Regarding: **HUNTINGTON BEACH ENERGY PROJECT (HBEP) (12-AFC-02)**
Staff's Data Requests, 73 through 98

**HUNTINGTON BEACH ENERGY PROJECT
(12-AFC-02)**

Energy Commission Staff's Data Requests 73-98

Huntington Beach Energy Project
Construction Schedule 11/30/2012

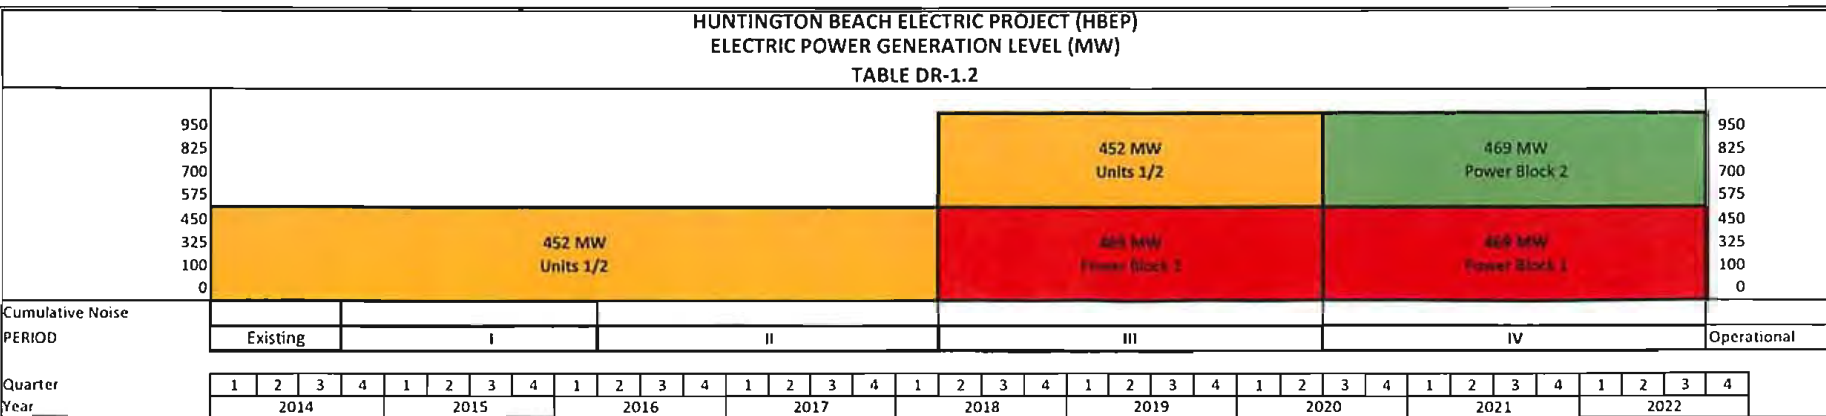
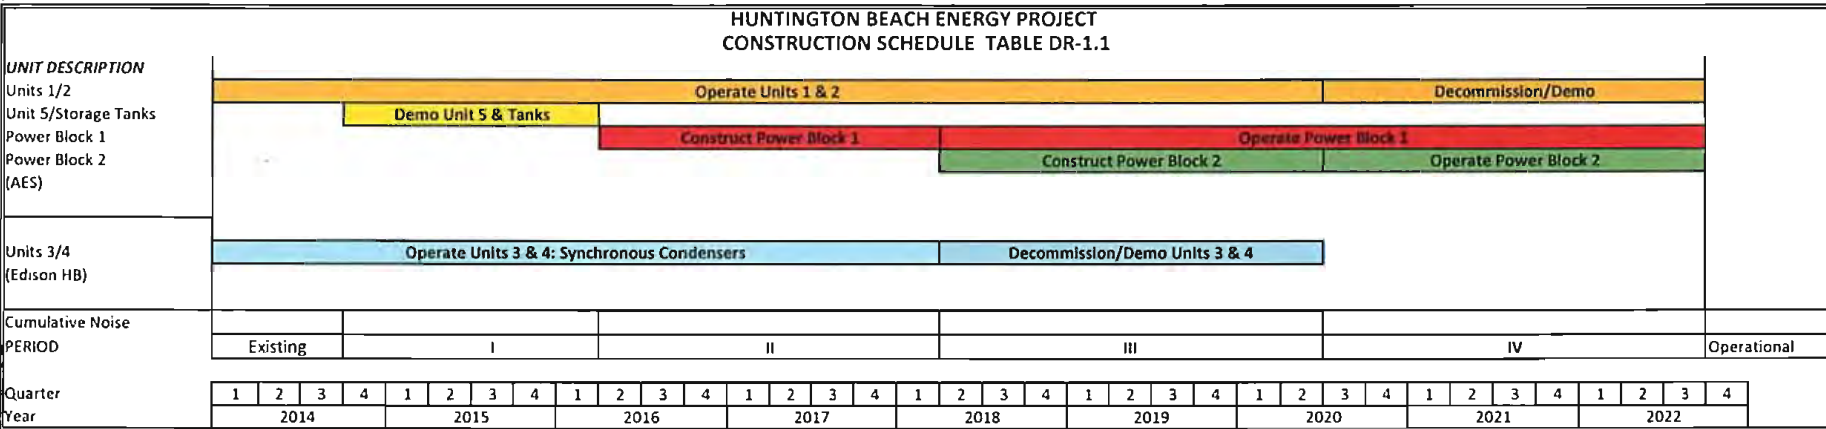
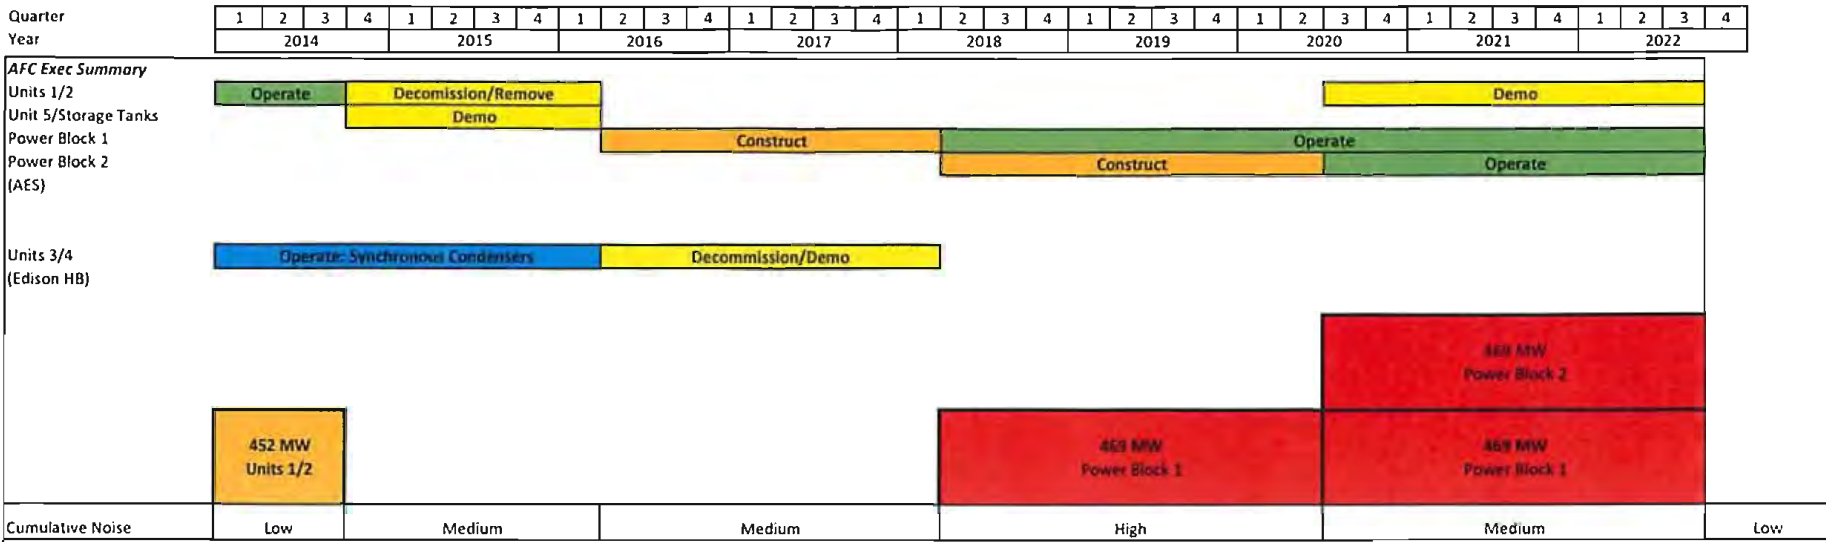
The operational requirements and space constraints of the existing HBEP site will require that demolition, construction, operation and decommissioning activities take place concurrently and over a period of eight years. HBEP will generate cumulative noise levels for up to 4 discrete time periods as outlined in **Table DR-73** below:

73. Please provide a noise analysis for each of the periods described above in **Table DR-73** above, showing the resultant noise levels at noise sensitive receptors M-1 through M-4. Please provide the results in terms of L_{eq} , L_{10} , L_{50} , L_{90} , L_{min} , and L_{max} .

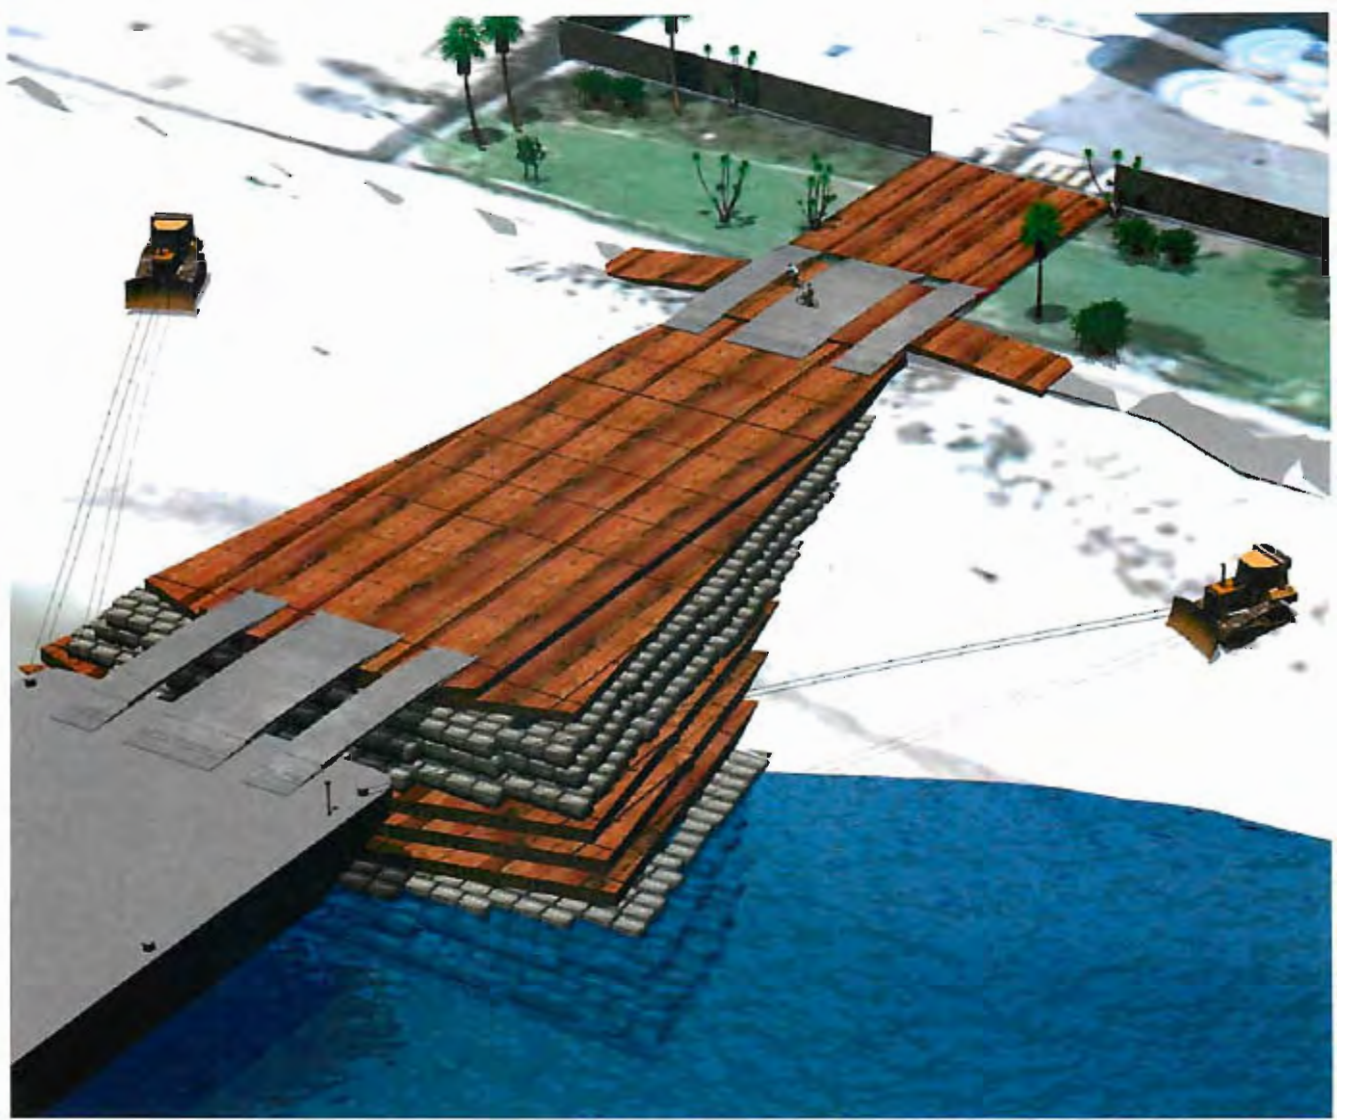
The City submitted a letter to Energy Commission staff requesting that the intersection analysis should include Magnolia Street and PCH. (City of Huntington Beach Letter, 12-6-2012, Comment #8, TN #68804). Energy Commission staff agrees that the Magnolia/PCH intersection should be included as part of the analysis. The City of Huntington Beach Circulation Element in the General Plan identifies Magnolia Street as a Primary Arterial and one of the primary north/south streets from the San Diego (I-405) Freeway which provides regional access to the City of Huntington Beach.

93. Please include PCH and Magnolia Street in the intersection analysis and amend Table 5.12-5 as reflected in the City of Huntington Beach LOS analysis.
